APPLICATION NO.	FILING DATE	FIRST NAMED INVENTOR	ATTORNEY DOCKET NO.	CONFIRMATION NO.
10/780,718	02/19/2004	Takashi Akita	2004_0240A	3209
513 7590 08/16/2007 WENDEROTH, LIND & PONACK, L.L.P. 2033 K STREET N. W. SUITE 800 WASHINGTON, DC 20006-1021			EXAMINER KIM, DAVID S	
			ART UNIT 2613	PAPER NUMBER
			MAIL DATE 08/16/2007	DELIVERY MODE PAPER

Office Action Summary

DETAILED ACTION

FIG. 6

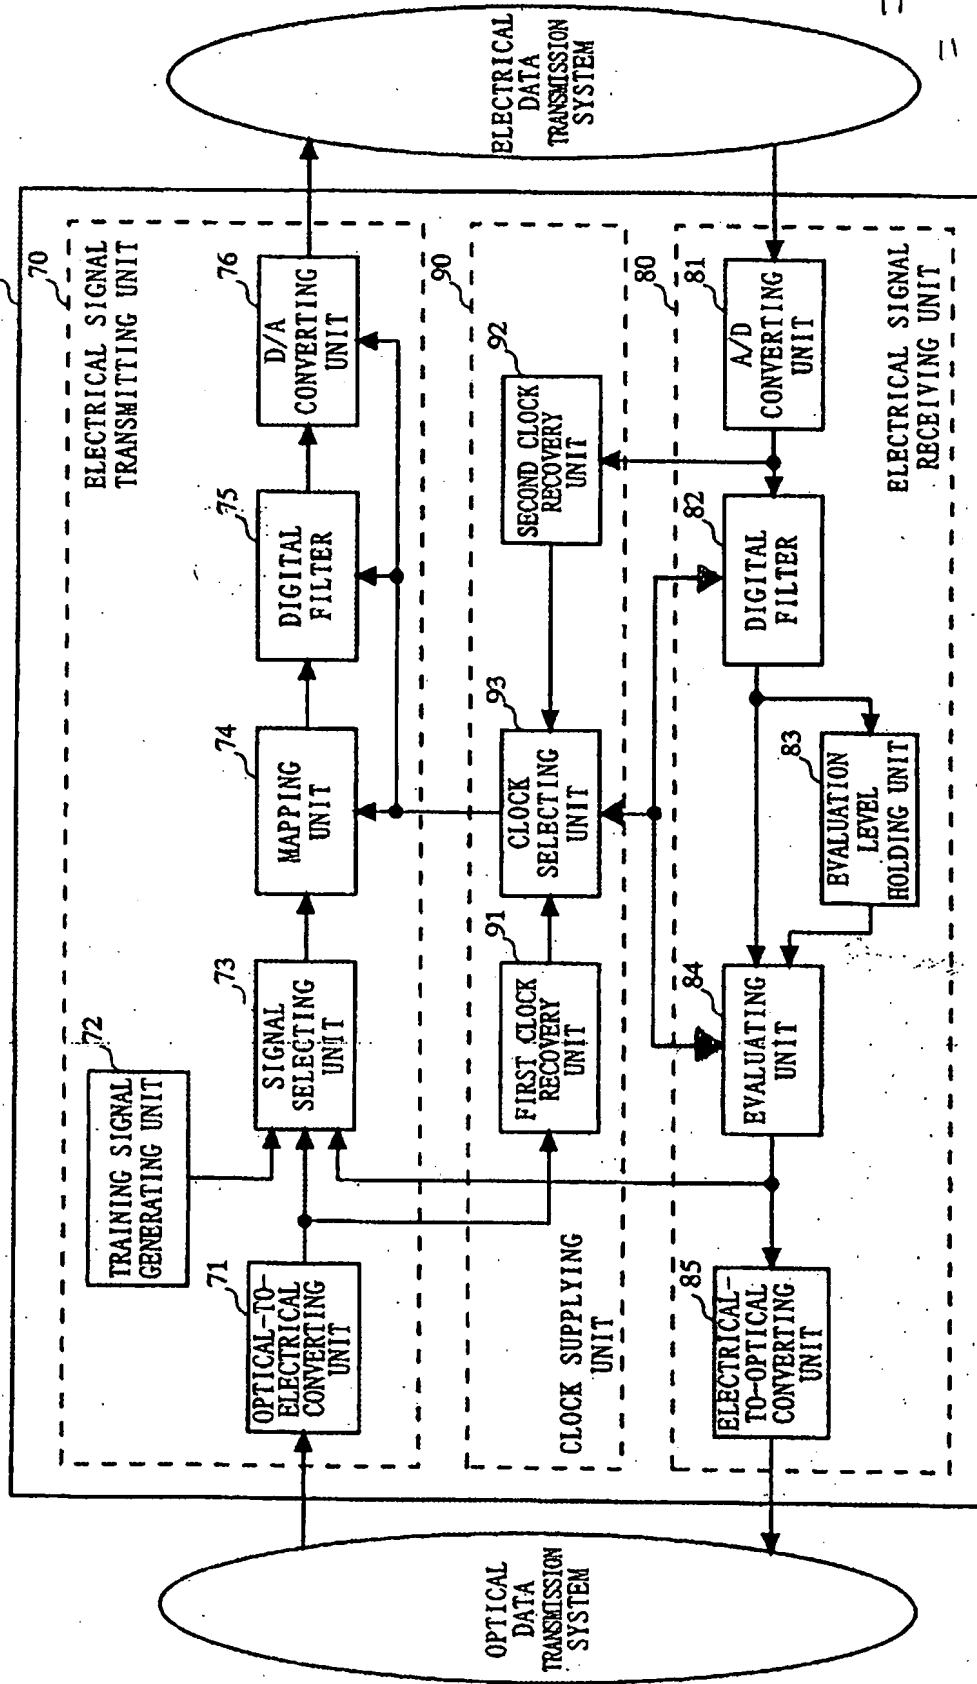
2. Applicant's response to the objection to the drawings in the previous Office Action (mailed on 09 February 2007) is noted and appreciated. Replacement drawings for Figs. 6-9 were received on 23 May 2007. However, these drawings are disapproved. These replacement drawings for Figs. 6-9 include a ***bidirectional*** link between clock selecting unit 93 and evaluating unit 84 and digital filter 82. However, Applicant's disclosure may only support a ***unidirectional*** link from clock selecting unit 93 to evaluating unit 84 and to digital filter 82.

The emphasized limitations suggest that Figs. 6-9 should show "electrical signal receiving unit" 80 with some input from "clock selecting unit" 93, but not an input to "clock selecting unit" 93 from evaluating unit 84 or from digital filter 82. Otherwise, the drawings include new subject matter that is not supported by Applicant's original disclosure. As a remedy, Examiner respectfully suggests drawing

Disapproved by DSK
11 AUGUST 2007

amendments that reflect the end of Applicant's paragraph [0044], which notes that the "processes by the digital filter 82 and the evaluating unit 84 are basically performed in accordance with the clock output from the clock selecting unit 93". That is, Examiner respectfully suggests a **unidirectional** link from clock selecting unit 93 to evaluating unit 84 and to digital filter 82.

FIG. 7

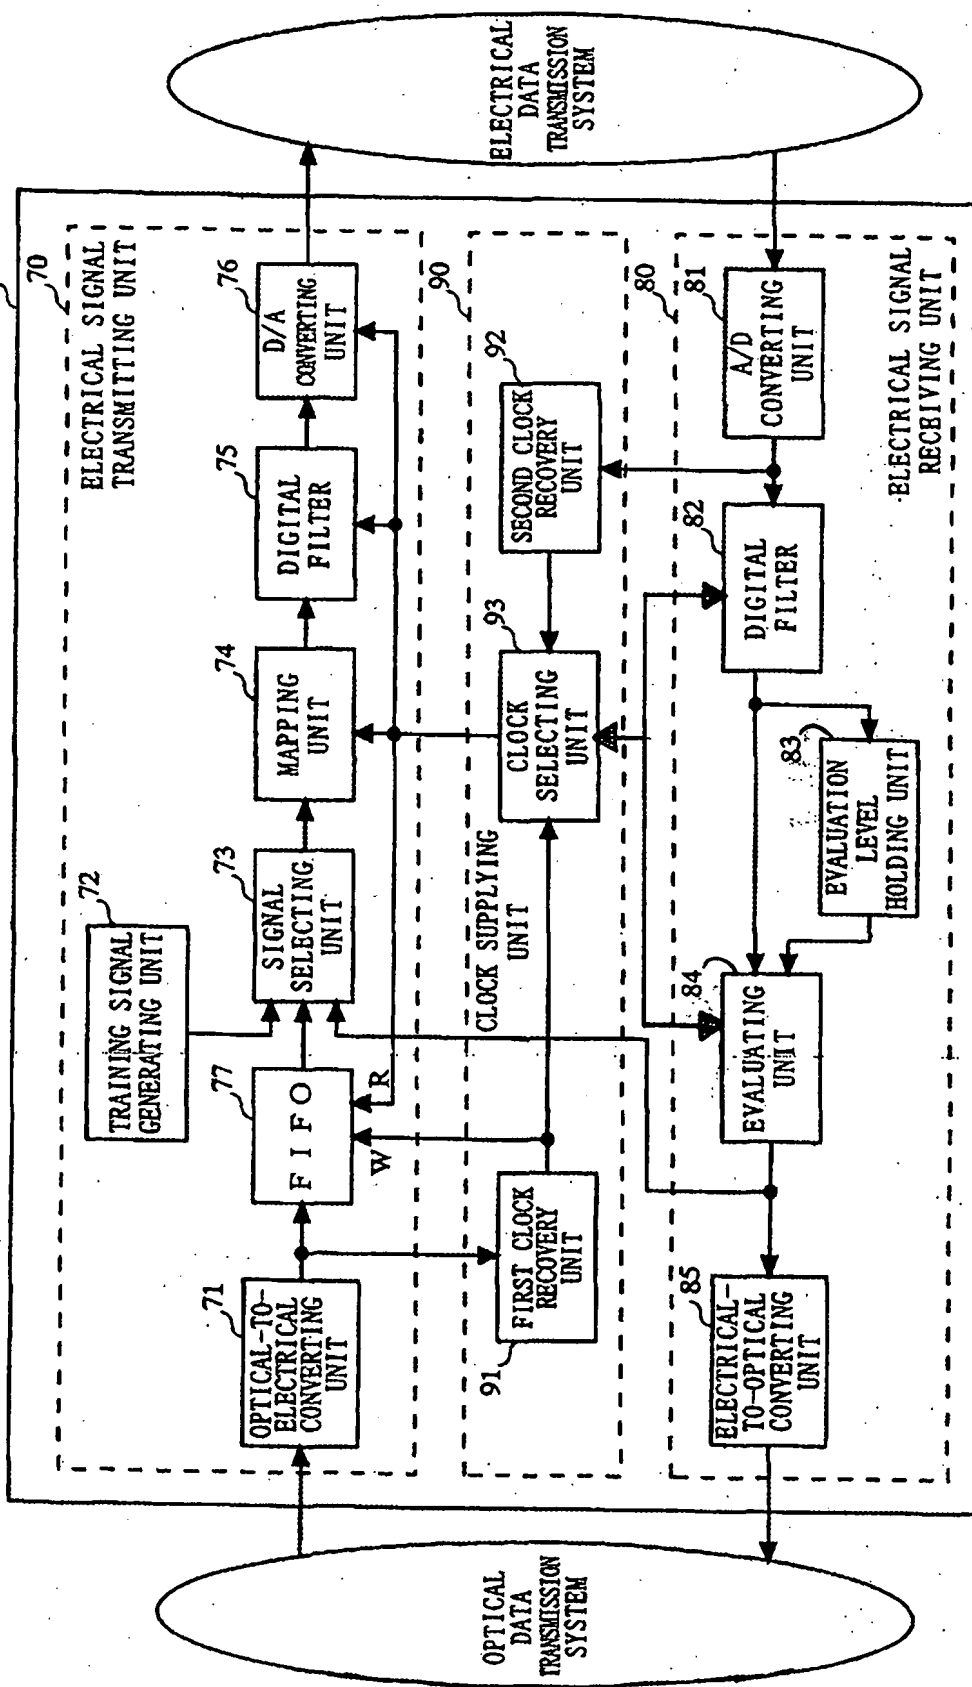
DB approved by DSK
11 AUGUST 2007

FIG. 8

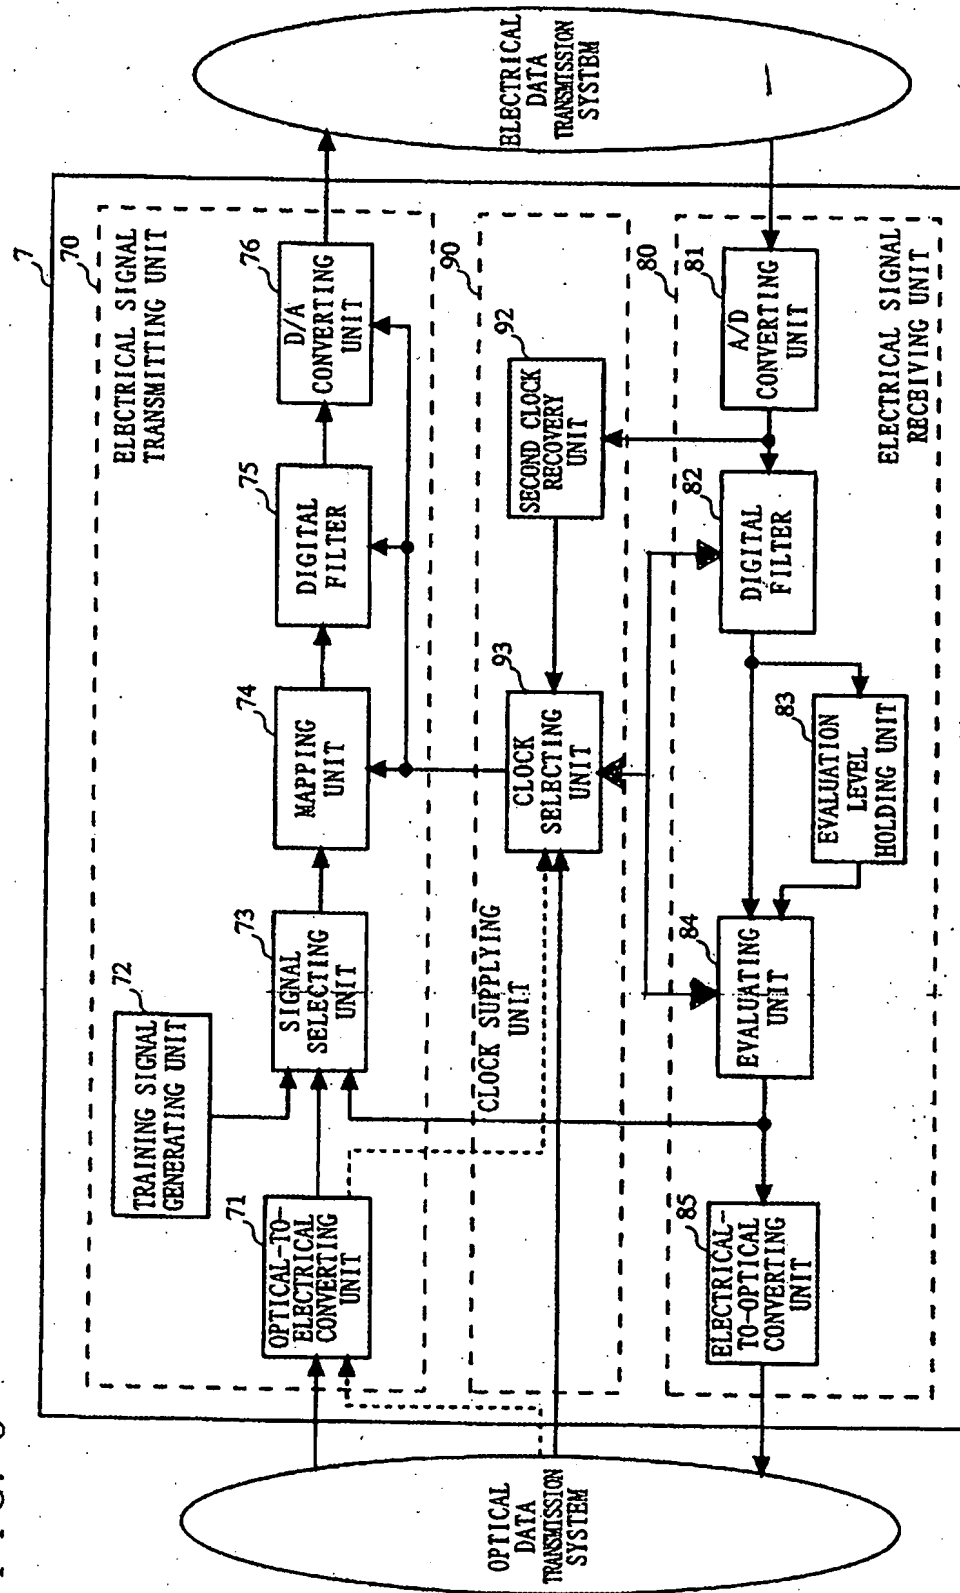
DB approved by PSK
11 AUGUST 2007
